# Cowlitz Indian Tribe

July 26, 2017

RE: Comments Regarding Water Quality Certification for the proposed Millennium Coal Terminal

Figure 6.7-2. Estimated Maximum Annual Coal Deposition—On-Site Alternative

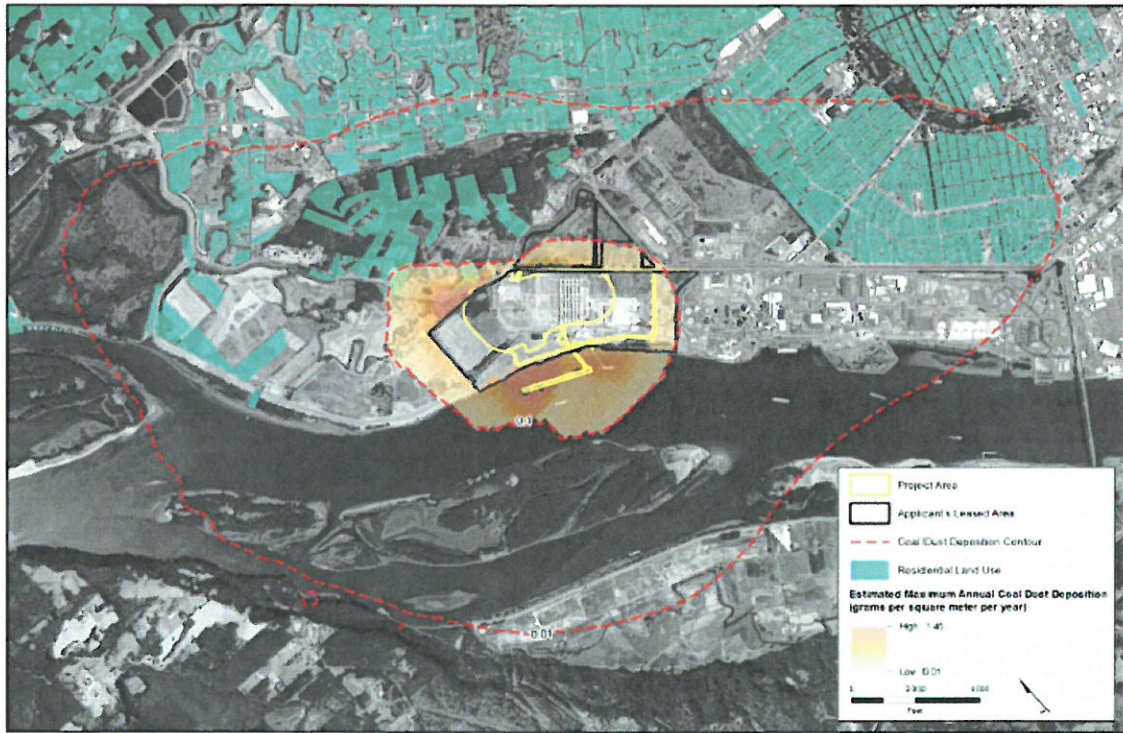
- Coal dust deposition is anticipated to be 1.45 grams per square meter, the highest off-site rate offered by the applicant’s research, in the off-channel slough vicinity. Creation of an off-channel rearing site would create an attractive nuisance in an area likely to become contaminated by coal dust and without

the flushing volume associated with the mainstem Columbia River (see our comment letter dated November 28, 2016 for full associated concerns with coal dust in the Columbia River)

The Millennium Coal Terminal proposed site coal dust deposition modeling illustrates that the heaviest coal dust deposition will occur over the Columbia River. When coal enters the Columbia River, it becomes part of the Columbia River sedimentation process. When it settles to the bottom, it impacts benthic organisms disproportionately. Coal impacts aquatic organisms in ways such as tissue abrasion and smothering or clogging of respiratory and feeding organs. This would have a higher impact on benthic invertebrates and bottom feeding fish, including sturgeon. Further up the food chain, invertebrate community changes could impact fish such as salmon and other higher order species.

Figure 29. Off-Channel Sloop Mitigation Site - Planting Plan

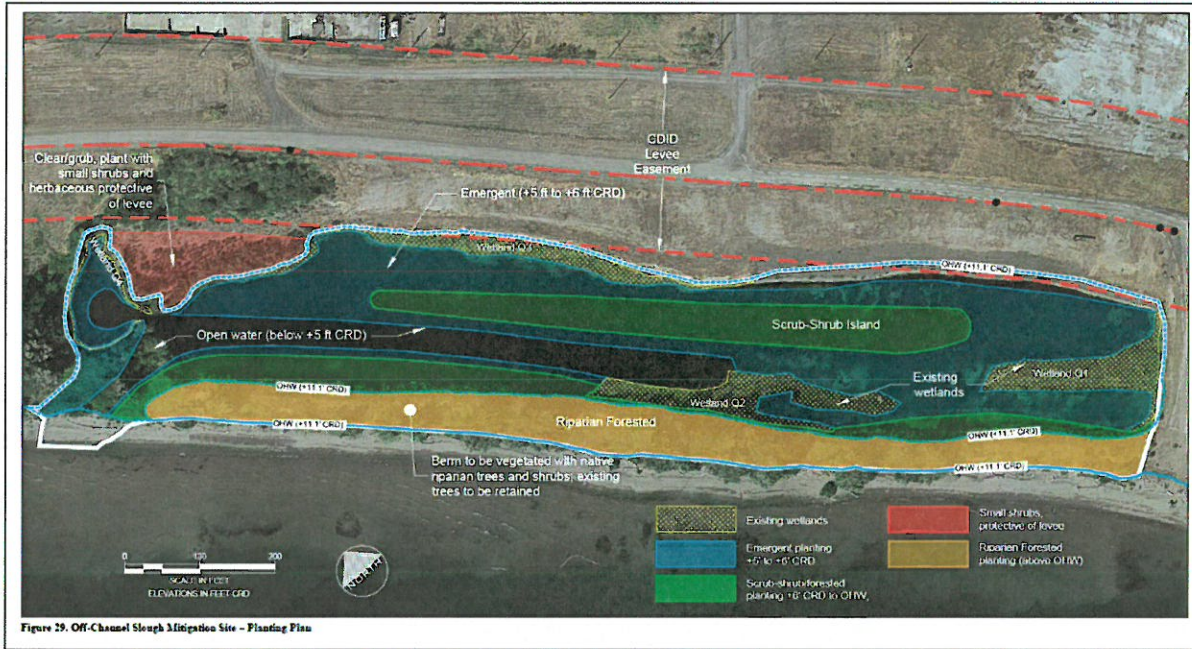
The proposal additionally purports to add 7.4 acres of new aquatic habitat. Reading through the section in detail, it is not until page 113 that an illustration finally makes clear what is proposed. And it is not 7.4 acres. It is a small open water slough with bordering scrub shrub and emergent wetlands. This is described, but not very well, on page 106 as 4.5 acres of native emergent, shrub and tree species. How does an open water area become a small slough? By putting 22,000 cubic yards of ‘suitable upland fill’ into the existing pond, grading it so it drains out (to reduce fish stranding potential) and then replanting to the emergent and shrub/scrub communities. The pond is currently between 0 and +4 feet in elevation, and after the project, the minimum elevation will be +4.

Millennium Bulk Terminals estimates they will impact 4.83 acres of aquatic habitat. If 7.4 acres of ‘new aquatic habitat’ subtracts 4.5 acres of wetland and upland enhancement, 3.5 acres of mitigation is proposed. Based on the model below, we suspect that even less aquatic habitat will be permanently created.
